St Margarets Chambers
For Charlotte Street Estates

Lightwell Elevations - Proposed Repairs and Conditions 2/2

scheme 1907
drwg no. **P(237)**
revision

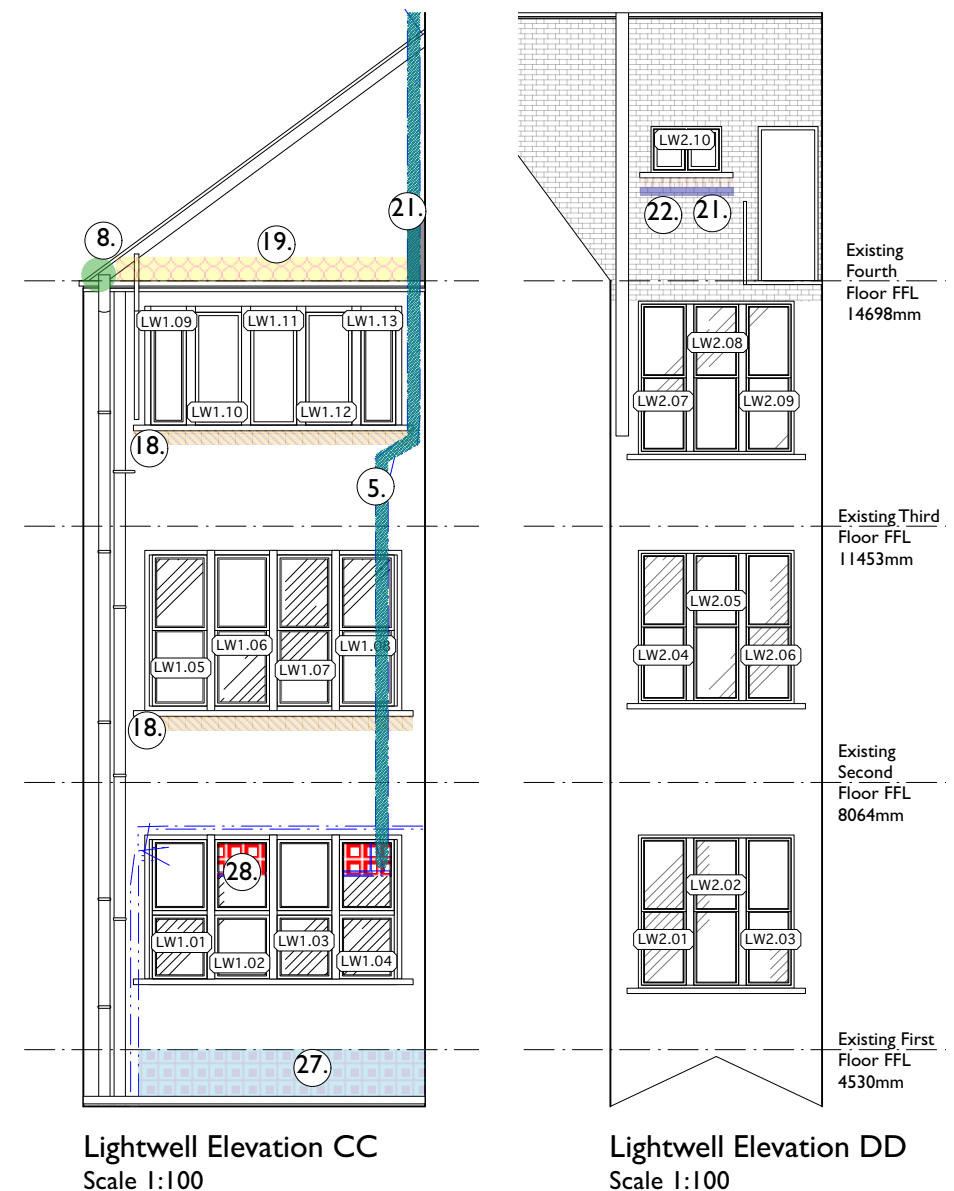
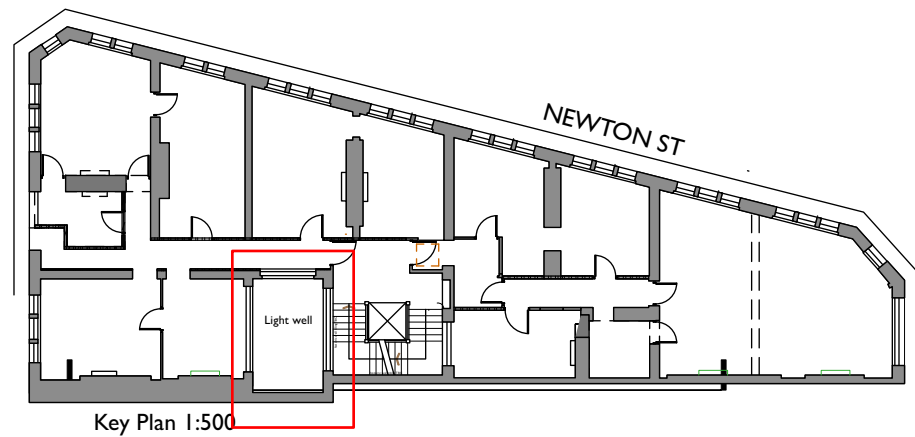
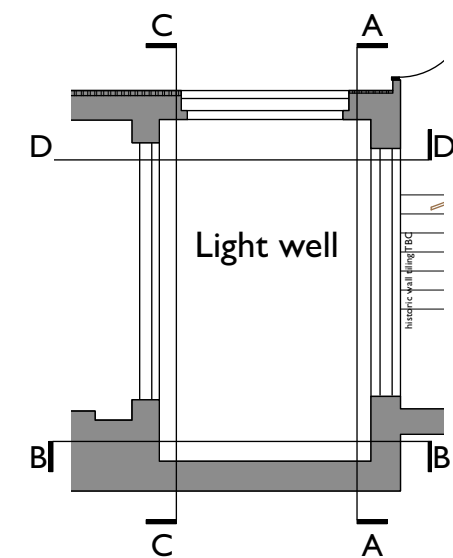
- 1 Sandstone erosion - close inspection required.
- 2 Holes left by redundant fixings - mortar fill in accordance with specification.
- 3 Gaps in brickwork. Close inspection required to inform replacement with matching material.

- 4 Missing pointing between frieze panels. Reinstall in accordance with specification.
- 5 Redundant plant equipment carefully remove and make good fabric in accordance with specification.

- 6 Eroded sandstone coping. Close inspection required. Replacement matching stone inserts may be required to prevent further deterioration.
- 7 Rusting lintels Clean off and repaint in accordance with specification.

- 8 Biological growth to be removed from roof level.
- 9 Coping water staining. May require repointing. Close inspection required.
- 10 Previous repairs to sandstone. Poorly matched aesthetic and presumed composition, but no evidence repairs are causing damage to surrounding historic fabric. Add to building maintenance plan for regular monitoring.

- 11 Biological growth to stone to be cleaned in accordance with specification.
- 12 Water staining may be caused by missing pointing. Close inspection required to inform repair strategy.

- 13 Signs of cracking. Further inspection required on site.
- 14 Redundant cables/lights/alarm box. Carefully remove
- 15 Residue from former sign to be cleaned off sandstone. Method pending site trials.

- 16 Existing timber to be carefully removed from brickwork

- 17 Clean off atmospheric dirt from glazed tiles
- 18 Redecorate cill
- 19 Clean-out gutters
- 20 Missing slate to be investigated once high level access provided
- 21 Repair and redecorate timber window frame and rotten cill
- 22 Clean concrete cill
- 23 Reinstall missing pointing
- 24 Inspect felt roof
- 25 Loose board and flashing to be repaired
- 26 inspect stone cill. Possible damage causing biological growth and staining to wall
- 27 Paint flanking and signs of damp further inspection required
- 28 Reinstall original sash configuration

Allow for the renewal of gutters and rainwater outlet to roof

Flashings to be renewed as required
